I-45 North Houston Highway Improvement Project

CHANGED FOR THE BETTER

What Changes Have Been Made?

Andrews Street reconnected to Downtown as a bicycle/pedestrian facility.

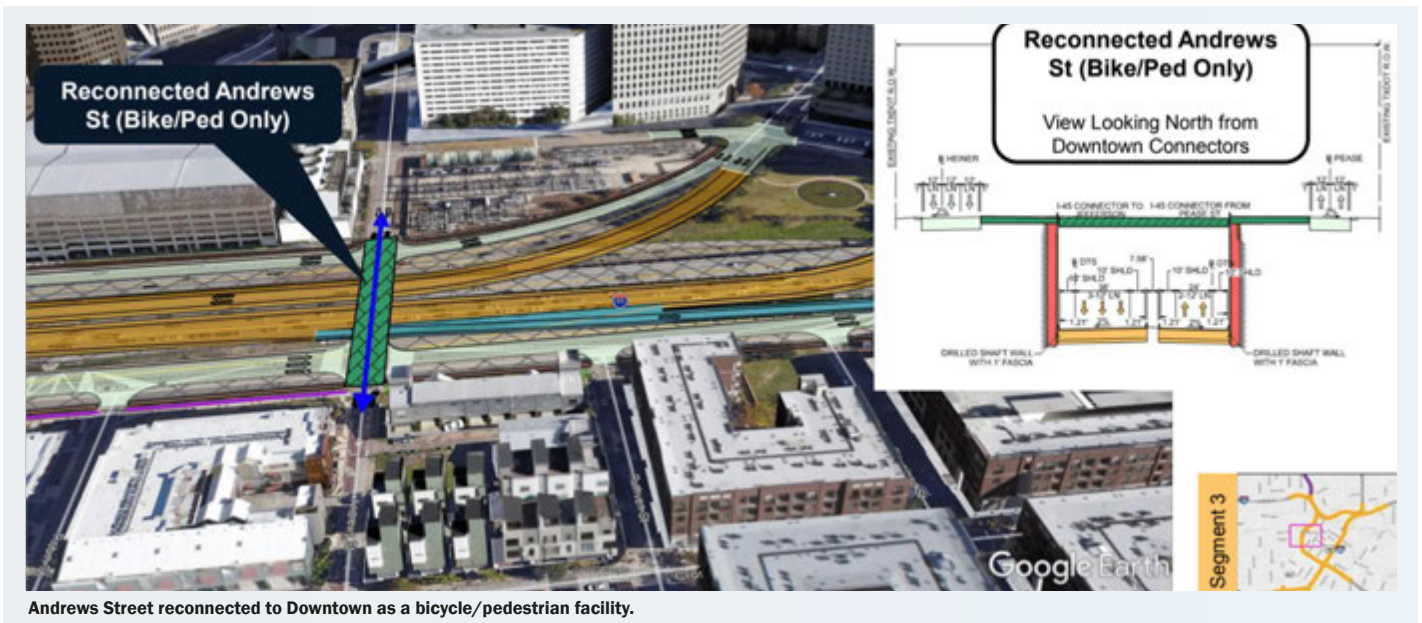
Another special request TxDOT received was to reconnect Andrews Street to Downtown, but as a dedicated bicycle/pedestrian connection. Andrews Street originally connected to Downtown before I-45 was constructed in the 1950s. This required TxDOT to make substantial changes to the Downtown Connector schematics so they could pass underneath Dallas and Andrews Streets. Please see figure below.
